BPC EAST PACKAGE 3 – CIPP PROJECT
Solicitation Number: CO-00422
Job No.: 19-4509

ADDENDUM 1
March 23, 2021

SHEET NO. **B-02**
 13 OF 41

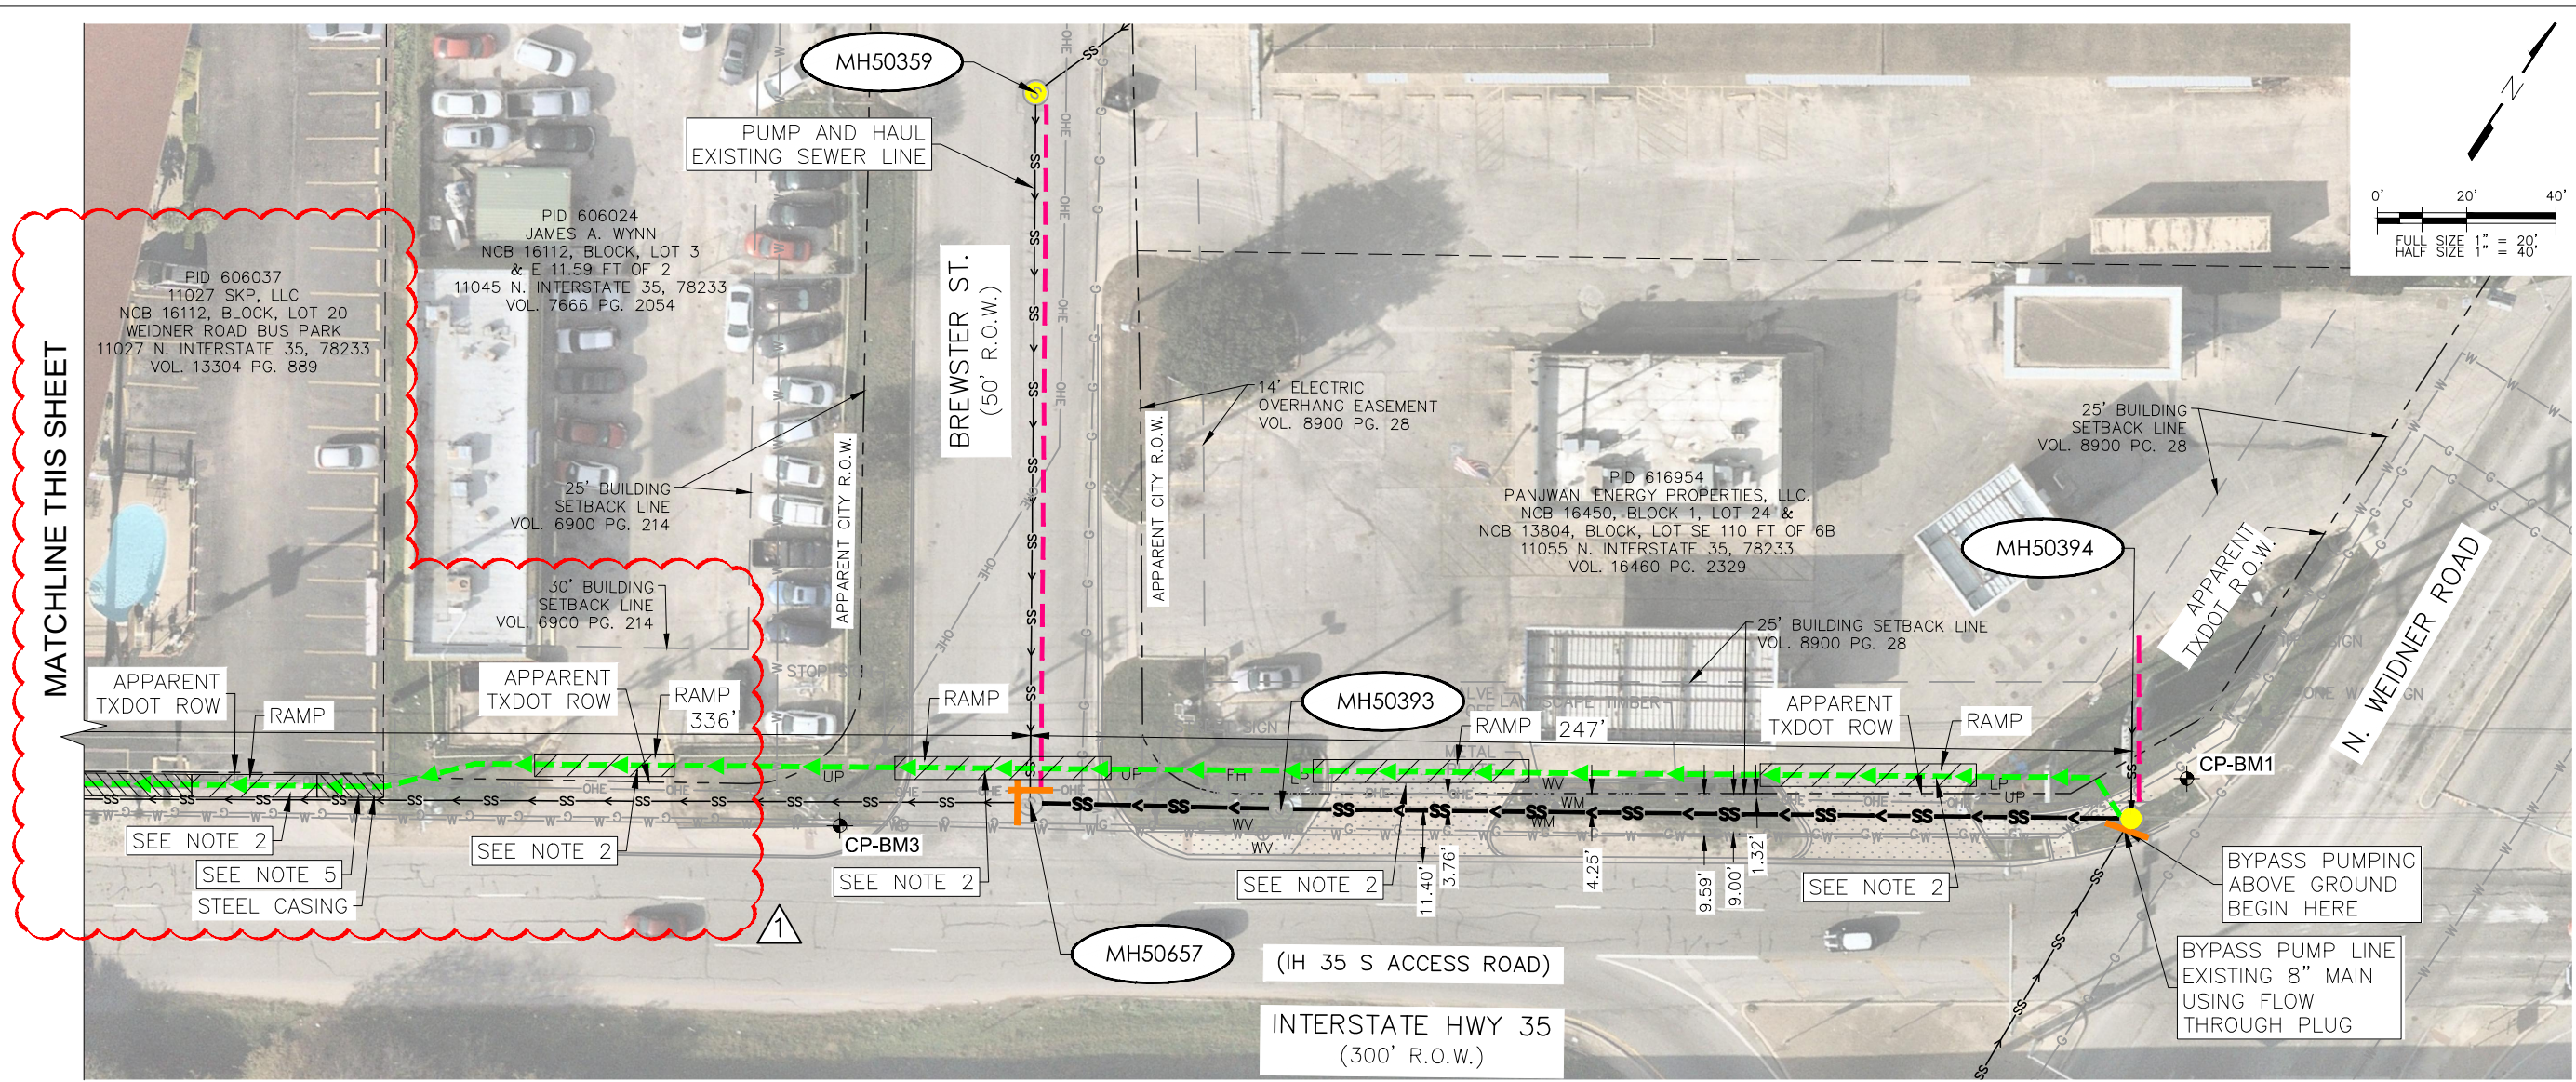
1. Remove and Replace Plan sheet B-01 to address property access requirements with additional barricades at Site C-9.
2. Remove and Replace Plan sheet B-02 to address additional bypass pumping pipe requirements and restrictions at Site C-9.
3. Remove and Replace Plan sheet TCP-02 to address additional traffic control requirements along with consideration for property access at Site C-9.

- NOTES:**
1. THE DISCHARGE LINES CAN BE ALIGNED ALONG/BELOW THE GREENBELT TO PROVIDE ACCESS FOR RESIDENTS. THE CONTRACTOR MAY BURY DISCHARGE LINES WHERE CONSTRUCTION IS TO OCCUR. CONTRACTOR MAY ALSO PROVIDE HIGH RATED PUMPS WHEN NECESSARY.

2. WHEN BYPASS LINES ARE ABOVE GROUND, RAMPs SHALL BE USED WHEN CROSSING A STREET OR DRIVEWAY.
 3. CONTRACTOR SHALL BE RESPONSIBLE FOR SUPPORTING BYPASS PIPING ACROSS DRAINAGE CHANNELS.

4. SEGMENT BETWEEN SUCTION AND DISCHARGE SHALL NOT BE PLUGGED FOR MORE THAN 8 HOURS WITHOUT BEING DRAINED. CONTRACTOR MAY USE LINK-SEAL PLUG AT DISCHARGE MANHOLE WITH A PUMP AND HAUL CONNECTION TO DRAW DOWN AS REQUIRED.

5. WHEN PERFORMING BYPASS INSTALLATION AT 11027 N. IH-35 (SUPER 8 MOTEL PROPERTY), CONTRACTOR SHALL INSTALL AS FOLLOWS:
 - A) THE SANITARY SEWER BYPASS PUMP LINE IS TO BE INSTALLED ABOVE GROUND ADJACENT TO THE CURB LINE CLOSEST TO IH-35. THE BYPASS LINE IS NOT TO BLOCK PARALLEL PARKING SPACES IN FRONT OF THE BUILDING.

- B) SANITARY SEWER BYPASS PUMP LINE IS TO BE INSTALLED IN A STEEL CASING TO PROTECT AGAINST TRAFFIC AND POTENTIAL CRUSHING OF THE BYPASS LINE (N.S.P.I.).

- C) ONLY ONE DRIVEWAY WILL BE CLOSED AT A TIME DURING THE INSTALLATION OF THE RAMPs.
 - D) BYPASS PUMP LINE INSTALLATION ON THE PROPERTY WILL OCCUR ONLY BETWEEN THE HOURS OF 12 PM AND 3 PM.
